29th Floor - M-529.00: Change Areas, Before and After

Snowflake Fitout - 7 Times Square, Floors 29-31 | COP-SF-05 Bulletin 3 Revision

29th Floor - M-529.00: Scope of Work and Cost Breakdown

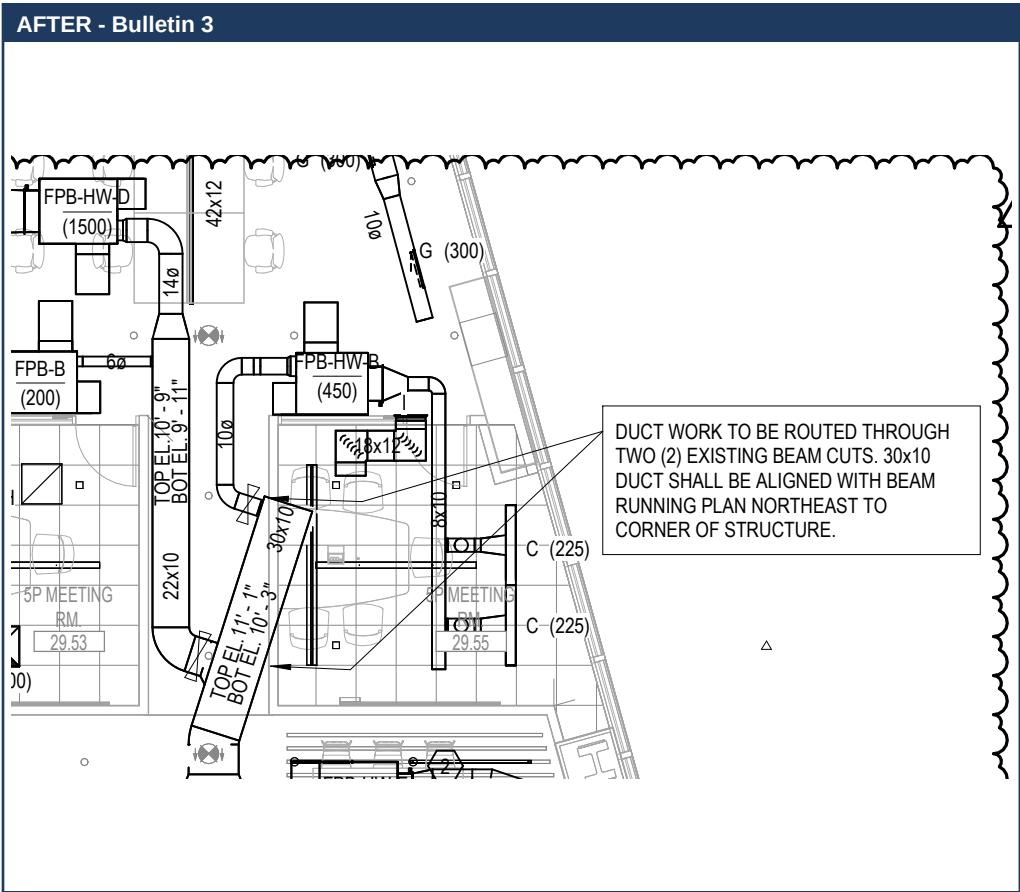
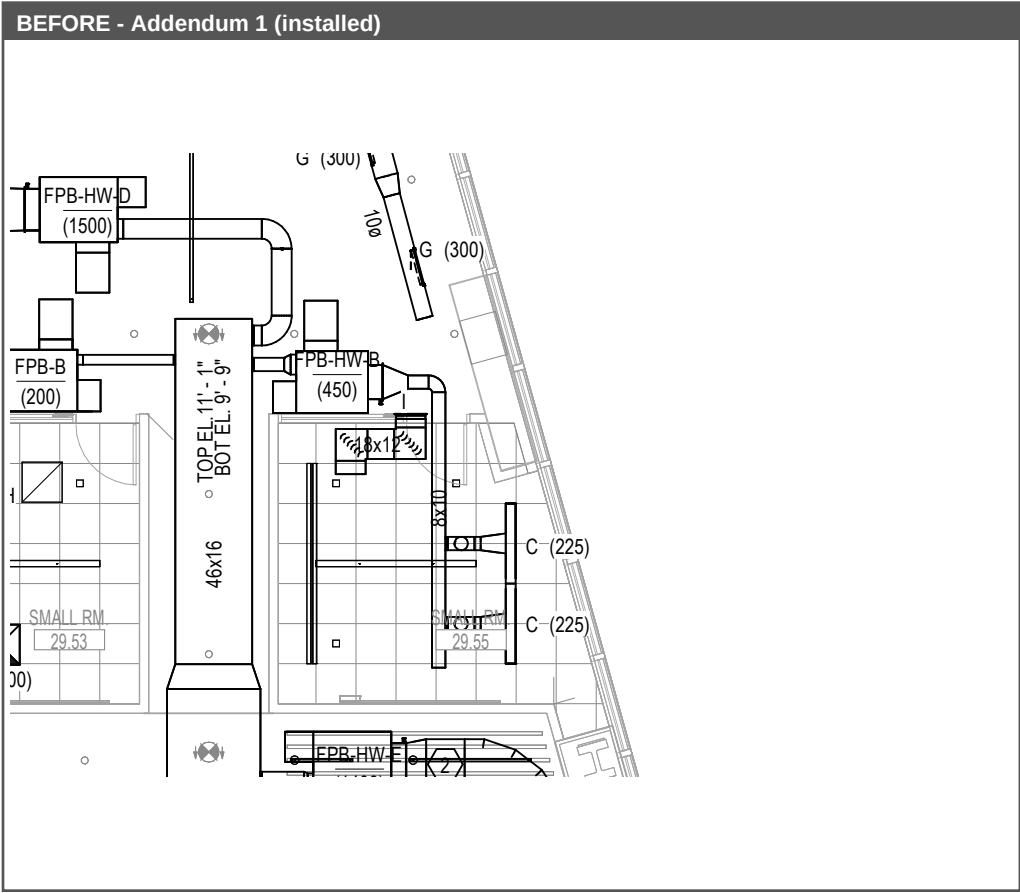
Before = Addendum 1 (fabricated and installed) After = Bulletin 3 (rev 4, 08/10/2026) | 29th floor total \$29,600 - scope and costs on next page

29-1 North supply main - reroute through existing beam cuts \$15,075

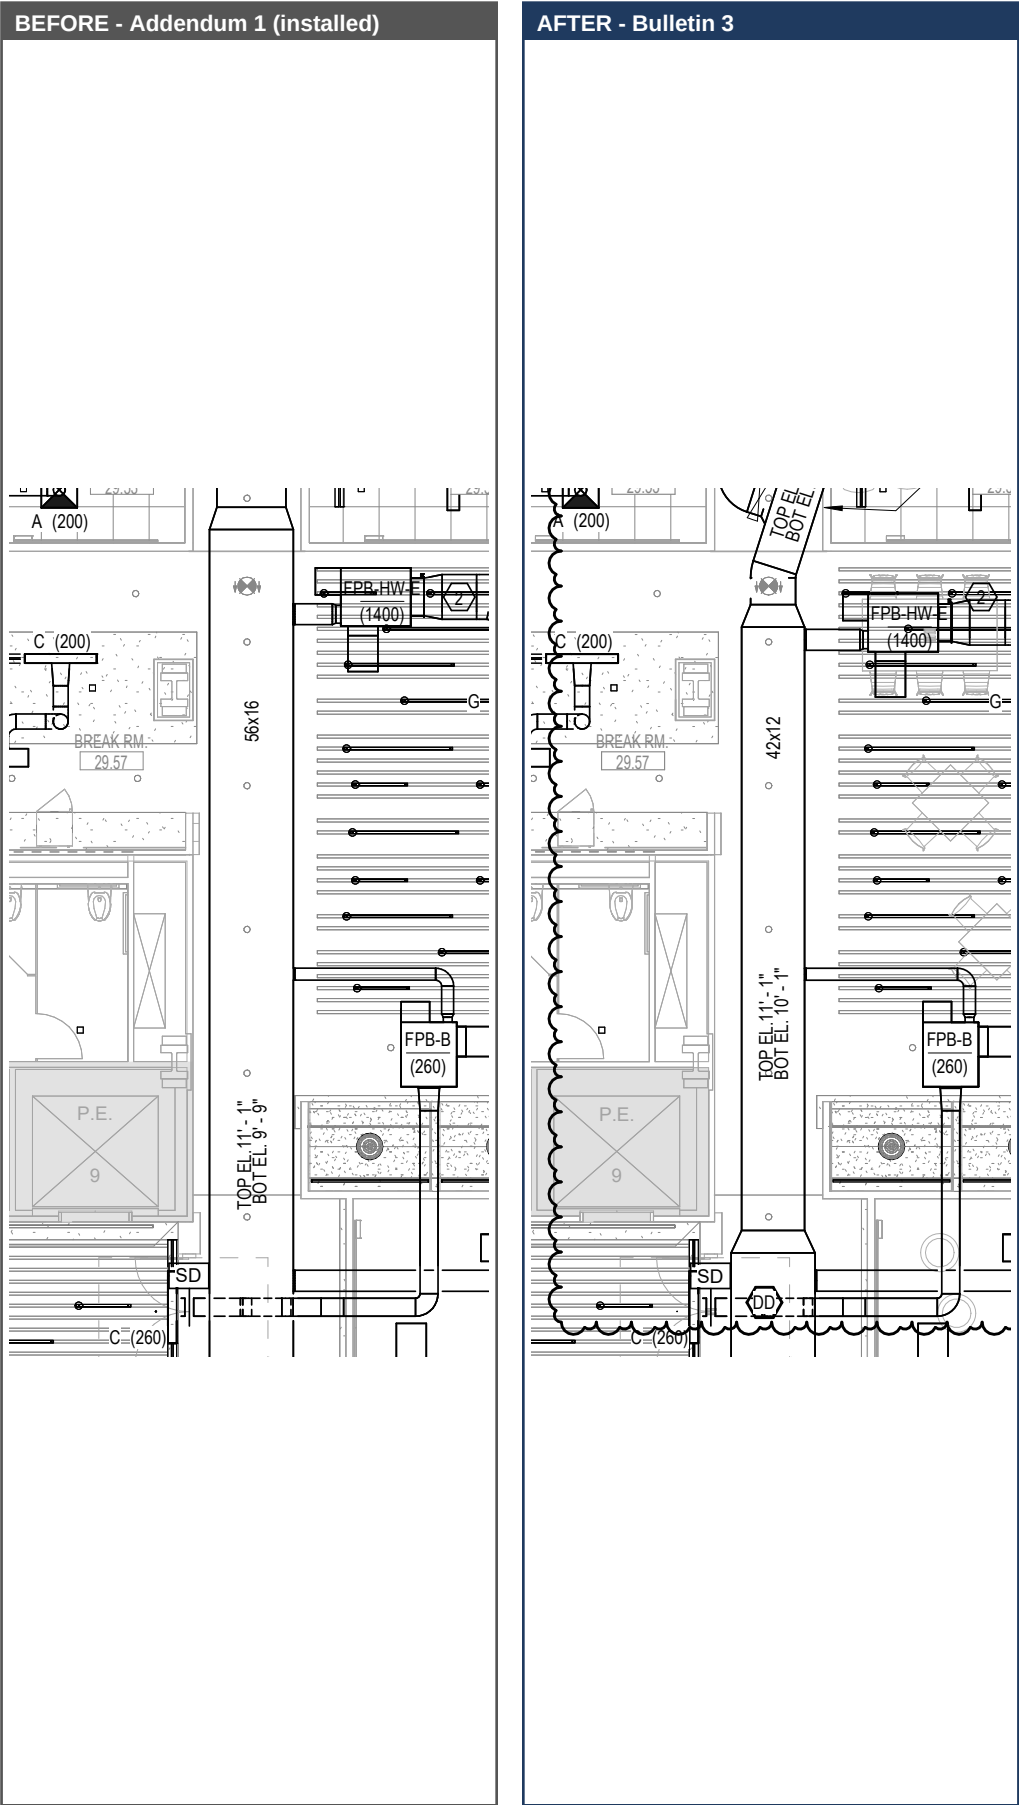
Area	Scope of work	Disconnect / removal	Material	Install labor	Total
29-1	North supply main - reroute through existing beam cuts Before: 46x16 supply main (approx. 20 LF, bottom el. 9'-9") with branch connections to FPB-HW-D (1500), FPB-HW-B (450) and FPB-B (200). After: Main rerouted as 22x10 and 30x10 through (2) existing beam cuts, 30x10 aligned with the beam running plan northeast. New 14ø branch to FPB-HW-D, 10ø to FPB-HW-B and 6ø to FPB-B. Work: Disconnect and remove installed 46x16 section and branch connections. Fabricate and install 22x10 / 30x10 duct and round branches with insulation, reconnect terminal units.	12 MH \$1,500	\$6,075	60 MH \$7,500	\$15,075
29-2	Supply main resized 56x16 to 42x12 Before: 56x16 supply main, approx. 44 LF, top el. 11'-1" / bottom el. 9'-9", Break Rm 29.57 to P.E. After: Main resized to 42x12 on the same route, top el. 11'-1" / bottom el. 10'-1". Work: Disconnect and remove installed 56x16 main. Fabricate and install 42x12 main with insulation, reconnect branch takeoffs (FPB-HW-E, FPB-B (260)).	7 MH \$875	\$3,900	50 MH \$6,250	\$11,025

30-1 IT Build Rm 30.23 / F&B Storage 30.14 / west dining \$6,700

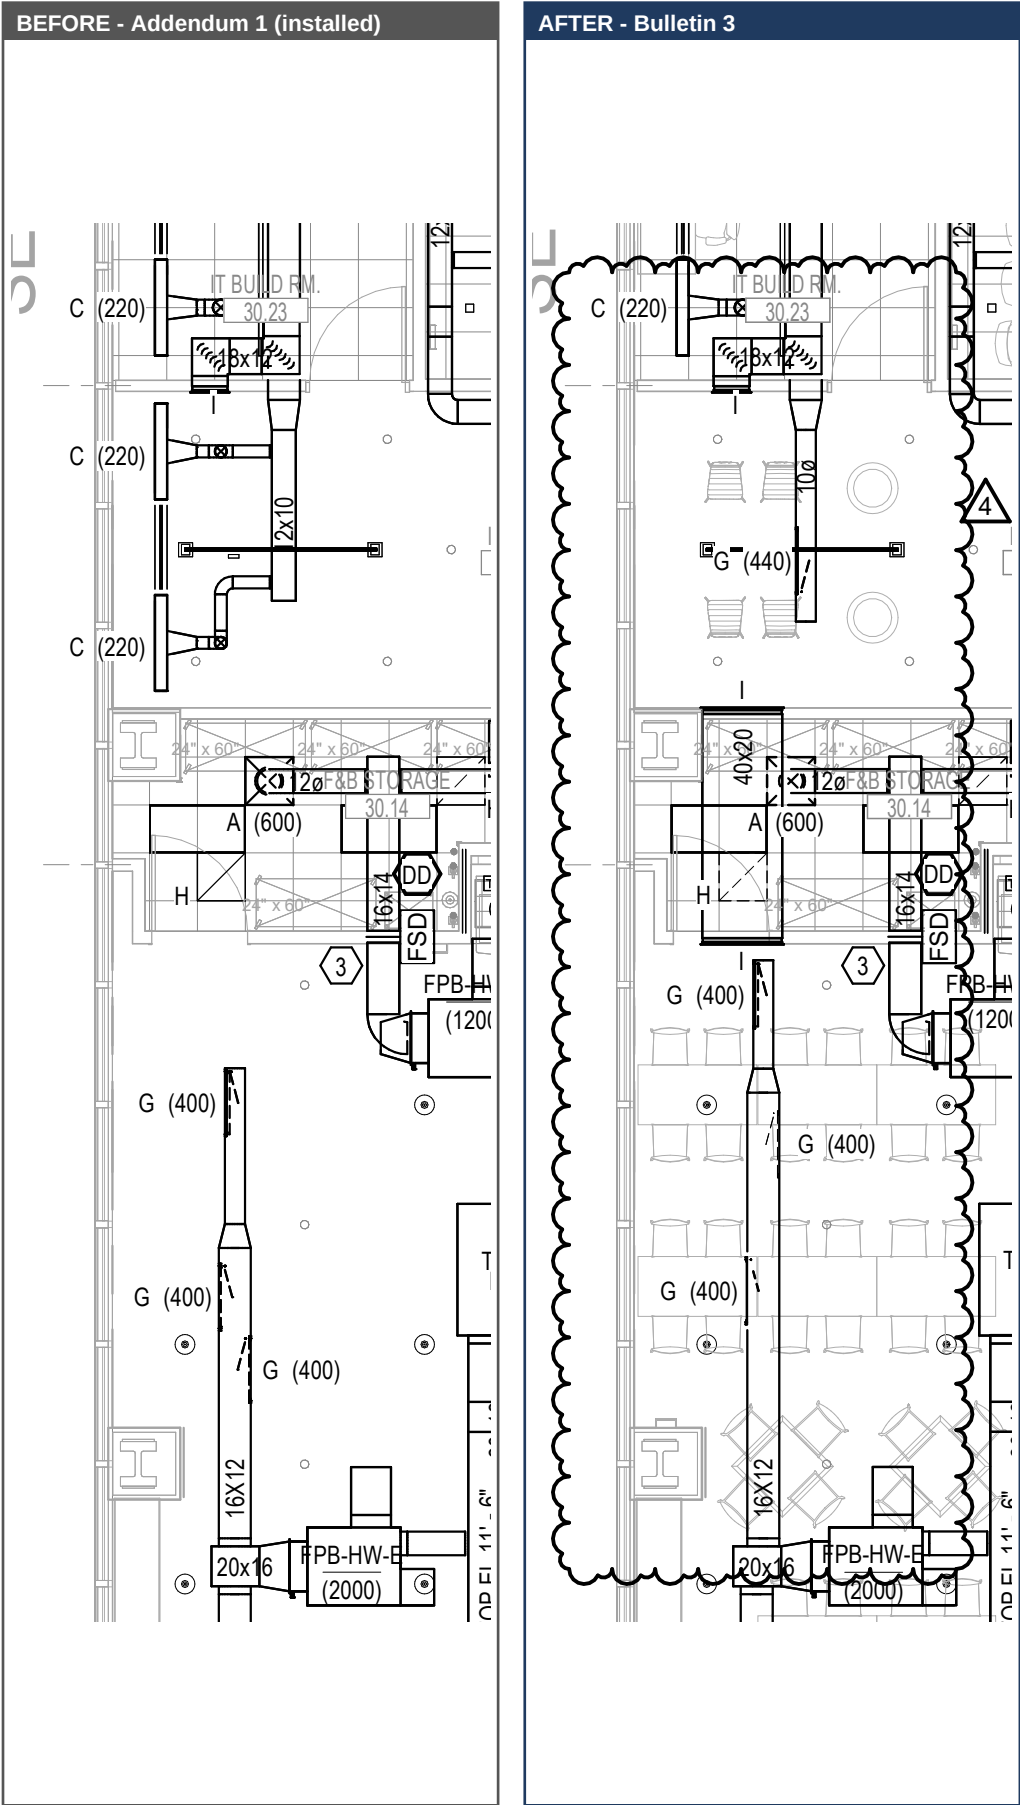
Area	Scope of work	Disconnect / removal	Material	Install labor	Total
30-1	IT Build Rm 30.23 / F&B Storage 30.14 / west dining Before: 12x10 branch with (2) C(220) ceiling diffusers; G(400) linear diffuser run on 16x12 branch. After: 12x10 branch and (2) C(220) deleted, replaced with 10ø branch to (1) new G(440) linear diffuser. New 40x20 transfer duct at F&B Storage 30.14. G(400) linear diffusers relocated along the 16x12 branch. Work: Disconnect and remove 12x10 branch and (2) C(220). Install 10ø branch, 40x20 transfer duct, rework 16x12 branch. F&I G(440) linear diffuser with plenum, relocate G(400) diffusers.	6 MH \$750	\$2,200	30 MH \$3,750	\$6,700
30-2	Lounge 30.02 - new transfer ducts Before: No transfer ducts at Lounge 30.02 walls. After: (2) new 48x24 transfer ducts. Work: Fabricate and install (2) 48x24 lined transfer ducts.	-	\$2,150	26 MH \$3,250	\$5,400
30-3	Meeting Rms 30.04 / 30.05, Storage 30.09, Vestibule 30.07 Before: FPB-HW-B (300) with supply connections; 44x20 transfer duct; (2) 12x12 grilles; 12ø branch to FPB-HW-D (1200). After: 44x20 transfer duct relocated; (2) 12x12 grilles relocated to 5P / 7P Meeting; 12ø branch rerouted. Work: Disconnect and remove affected duct, fittings and grilles. Install 44x20 transfer duct and 12ø branch at new locations.	16 MH \$2,000	-	24 MH \$3,000	\$5,000

31-1 Zoom rooms, northwest - transfer ducts \$1,205

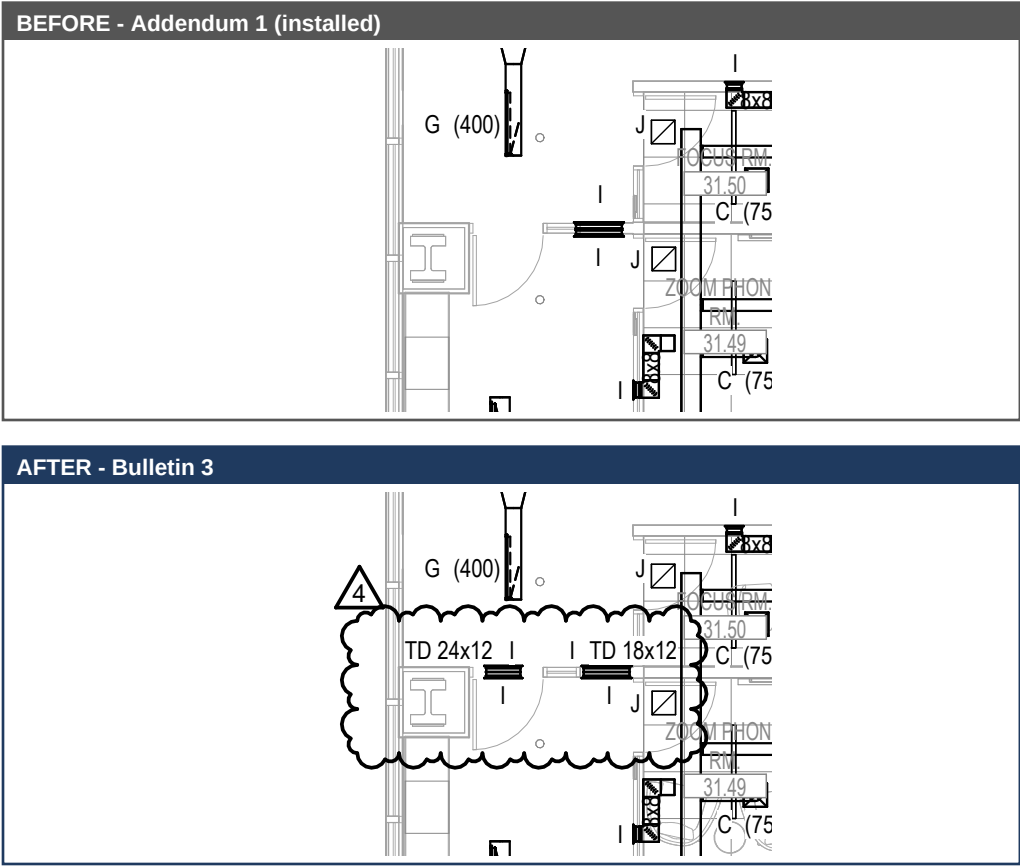
Area	Scope of work	Disconnect / removal	Material	Install labor	Total
31-1	Zoom rooms, northwest - transfer ducts Before: (1) transfer duct (not sized on Addendum 1). After: TD 24x12 and new TD 18x12. Work: Remove existing transfer duct; fabricate and install TD 24x12 and TD 18x12.	1 MH \$125	\$330	6 MH \$750	\$1,205
31-2	Transfer duct TD 32x16, north Before: Transfer duct as installed per Addendum 1 (not sized on Addendum 1). After: Transfer duct revised to TD 32x16. Work: Remove installed transfer duct; fabricate and install TD 32x16.	1 MH \$125	\$300	5 MH \$625	\$1,050
31-3	Storage 31.02 - new transfer ducts Before: No transfer ducts; volume damper at FPB-HW-B (500) branch. After: (2) new 44x22 transfer ducts. Work: Fabricate and install (2) 44x22 lined transfer ducts.	-	\$1,700	20 MH \$2,500	\$4,200
31-4	Coffee Bar 31.12 - transfer ducts and main fitting Before: 36x18 main with elbow at Coffee Bar 31.12; no transfer ducts. After: (2) new TD 28x16; 36x18 main elbow reconfigured. Work: Disconnect and remove 36x18 elbow; fabricate and install new fitting and (2) TD 28x16.	6 MH \$750	\$1,700	24 MH \$3,000	\$5,450

31-5 Transfer duct TD 32x16, southwest \$3,150

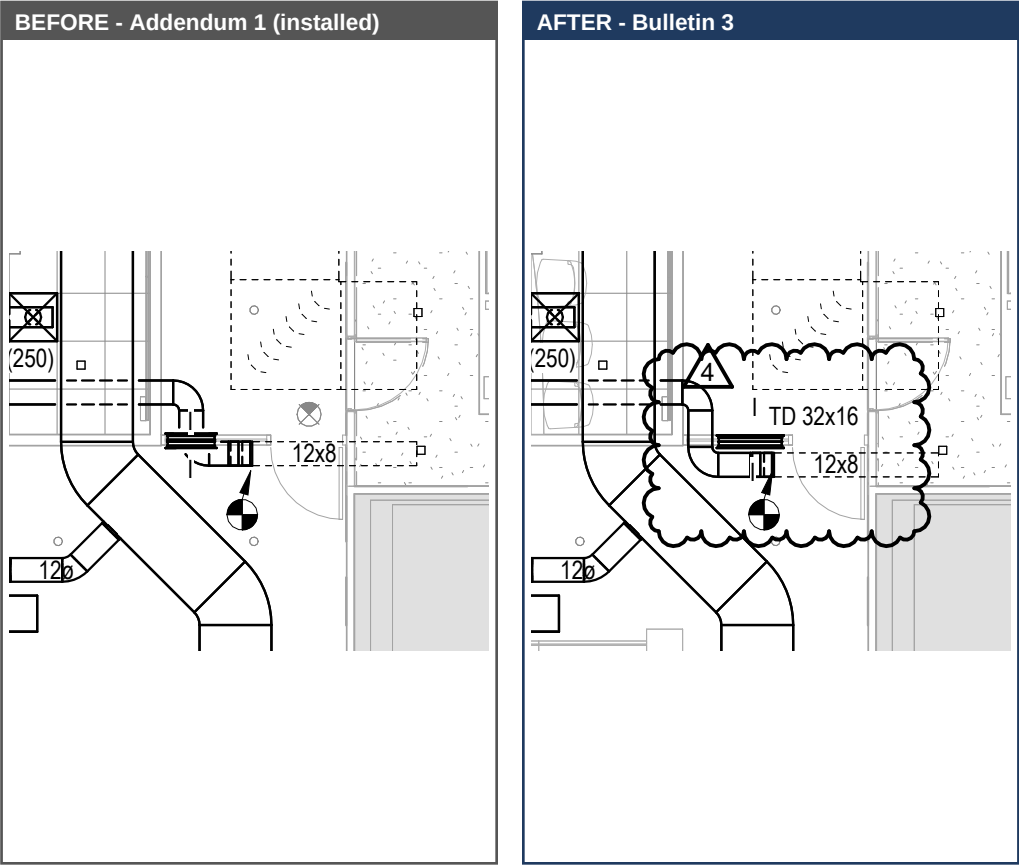
31-5	Transfer duct TD 32x16, southwest Before: Transfer duct and duct elbow as installed per Addendum 1, next to the 12x8 branch. After: Transfer duct revised to TD 32x16; elbow deleted. Work: Remove installed transfer duct and elbow; fabricate and install TD 32x16.	4 MH \$500	\$650	16 MH \$2,000	\$3,150
31-6	Storage 31.15 / Room 31.16, southeast Before: 12x12 and 18x12 grilles at previous locations; no transfer duct at Storage 31.15. After: New TD 48x24; 12x12 and 18x12 grilles relocated. Work: Remove grilles and their duct connections; fabricate and install TD 48x24, relocate 12x12 and 18x12 grilles with duct connections at new locations.	5 MH \$625	\$900	12 MH \$1,500	\$3,025
	Shop drawings for revised design				\$1,000
	31st floor total (17 MH disconnect, 83 MH install)	\$2,125	\$5,580	\$10,375	\$19,080
